HILCORP ENERGY COMPANY

30-039-22211 SAN JUAN 30 6 UNIT #088A

Hilcorp Energy Company plans to recomplete the subject well in the Pictured Cliffs formation and downhole commingle with the existing Mesaverde. Attached is the PC C102, recomplete procedure & wellbore schematic. The DHC application will be submitted and approved prior to commingling. A closed loop system will be utilized. Interim reclamation will be performed after surface disturbing activities.

Attachment to notice of Intent to Recomplete & Commingle

SAN JUAN 30-6 UNIT 88A - CURRENT WELLBORE SCHEMATIC

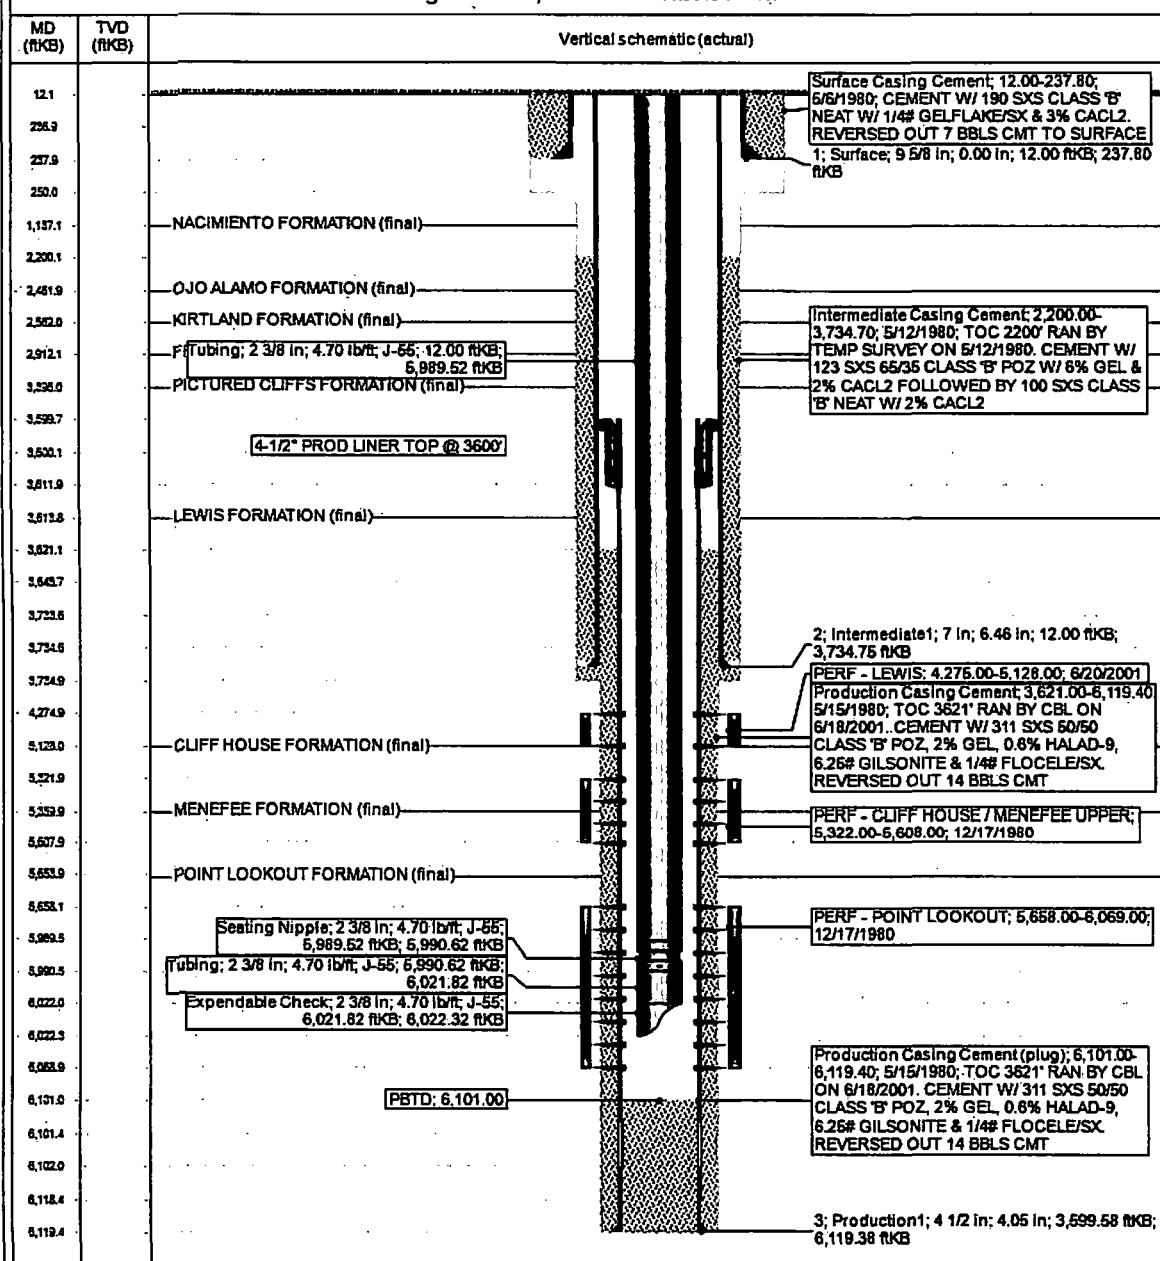
2. The following modifications to your recompletion program are to be made:

- a) Upon rigging up, record Bradenhead pressure and monitor same during recompletion operations. Notify BLM and NMOCD if anomalous pressure changes occur. Provide monitoring results in the subsequent Report of Operations.
- b) Casing pressure test for fracture stimulation operations cannot exceed the internal yield strength of the casing including a 20% safety factor unless a waiver is granted. Stimulation operations cannot exceed this test pressure.
- c) CIBP for base of fracture stimulation to be set less 50' above top existing perforation.
